Service Bulletin	
	Flight Design GmbH Zum Tower 4 01917 Kamenz Germany Tel.: +49 (0)3578 37335 0 Fax: +49 (0)3578 37335 69 E-Mail: airworthiness@flightdesign.com	SB-ASTM-CTLS-12 Revision 01
	Date of Initial Publication: 18-Nov-2015 Publication Date of this Revision: 02-Dec-2015

in the level of a Service Directive
USA Data Plate Replacement
SB-ASTM-CTLS-12

Fig. 1 – Location B data plate is affected

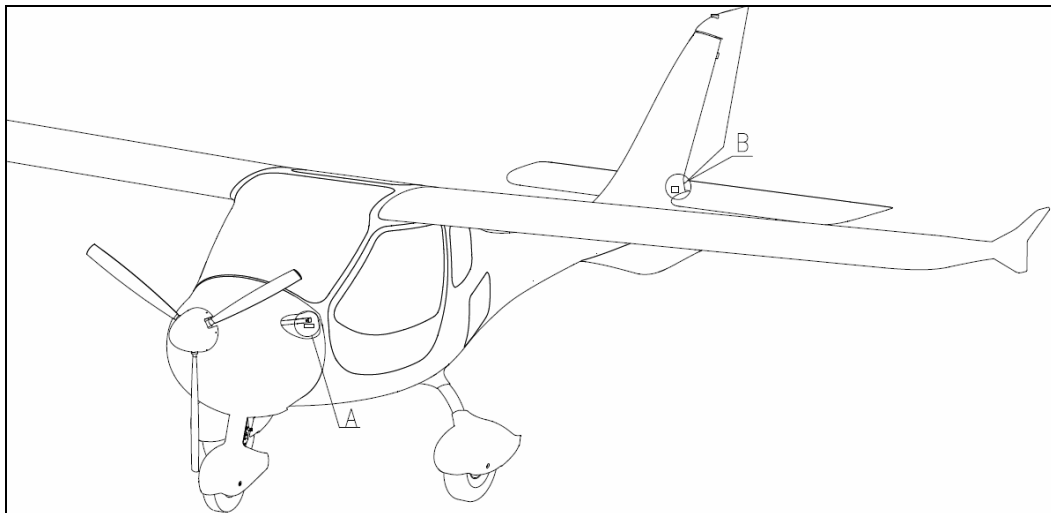
The rear data plate attached to the left side of the aircraft tail is replaced with an updated data plate that shows the country of origin. The exchange is done in a controlled way, to ensure proper replacement, receipt and disposal of the removed data plates.

- **Caution:** This instruction only affects the data plate attached to the left hand side of the tail boom of your aircraft (location B in Fig. 1). The data plate installed to the firewall is not affected.

Fig. 2 – Installation of the Data Plate (1 – Data Plate; 2 – Rivet; 3 – Washer)

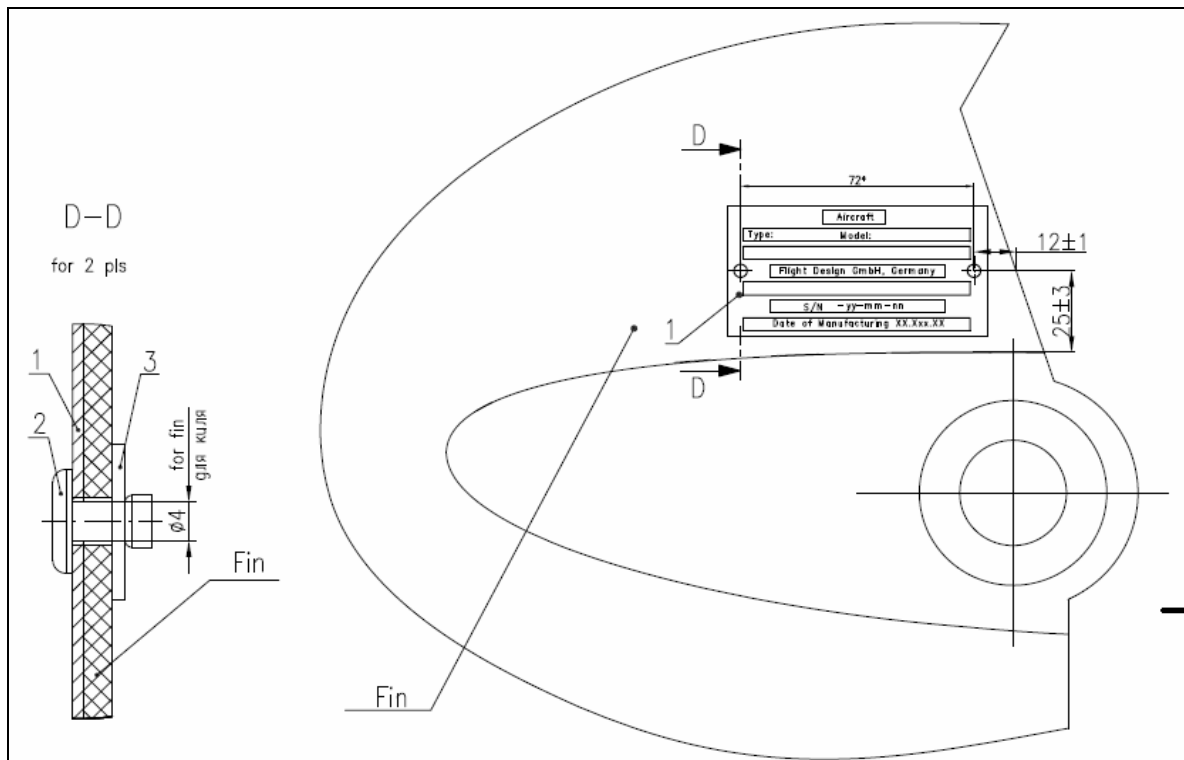
The data plate comes pre-drilled. Position the data plate to the tail fuselage using the 2 rivets.

Apply one washer on the rear side of the rear rivet and ensure the washer lies flat relative to the composite fuselage tail boom structure. Pull the blind rivet using the riveting tool. Repeat for the forward rivet.
